UNITED STATES
DEPARTMENT OF THE INTERIOR
BUREAU OF LAND MANAGEMENT
SUNDRY NOTICES AND REPORTS ON WELLS

Well Name: Arco 20 Federal Com #2		Field: AVALON	
Location: Sec 20-215-26E, 1320' FSL & 2323' FWL		County: Eddy	State: NM
Elevation: GL 3449', KB 3461'		Spud Date: 05/12/99	Compl Date: 10-8-99
API#: 30-015-30599	Prepared by: Ronnie Slack	Date: 7/23/07	Rev:

PROPOSED PLUG & ABANDONMENT

**Arco 20 Federal Com 2
Devon Energy Production Company, LP
July 31, 2007
Plug and Abandonment
Conditions of Approval**

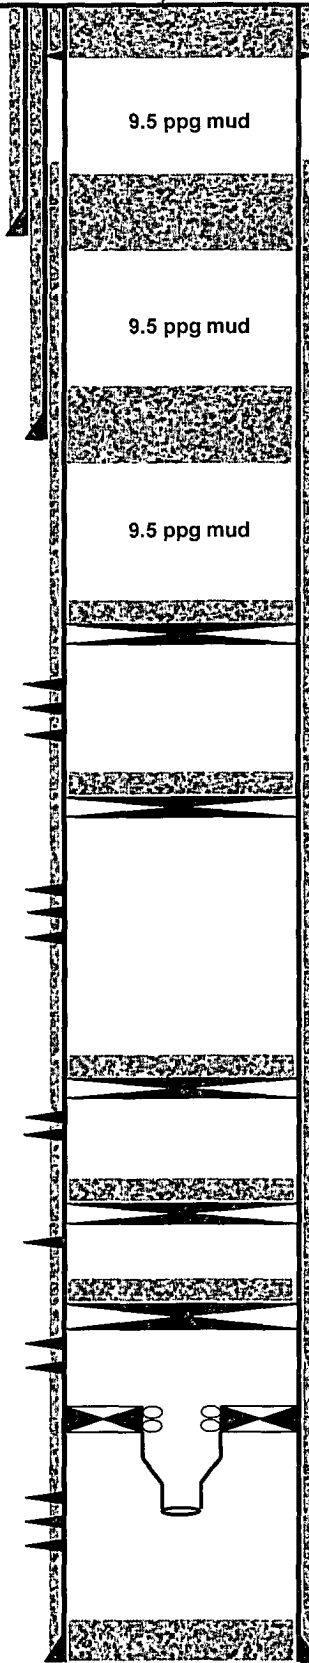
1. CIBPs at 3090' and 3250' must be drilled out due to inadequate plugs below CIBP at 3250'.
 - a. Plug required at top of Wolfcamp at 8400'. Plug to be set at 8450' and be 185' in length, minimum of 25 sacks.

- b. Plug required due to spacing requirement of no more than 3000' between plugs in casing. Set plug at approximately 6500'. Plug to be 165' in length, minimum of 25 sacks.

- c. Plug required at top of Bone Spring at 4549'. Plug to be set at 4600' and be 150' in length, minimum of 25 sacks.
 - d. Replace plugs for Brushy Canyon or pump sufficient cement to extend 50' below lowest perforation at 3886' and 50' above highest perforation at 3140' (approximately 145 sacks). If cement is pumped, plug is to be tagged.

2. Plug to be extended to top of Delaware at 2341'. Plug to be set at 2400' and include shoe plug. Tag plug at 2060' or shallower.
3. Geological report when well was drilled indicated fresh water to 650'. Plug to be extended to cover this depth inside the casing (approximately 50 sacks). Tag plug at 390' or shallower.

4. Minimum 25 sack plug per NMOCD guidelines.
5. Ok
6. Ok
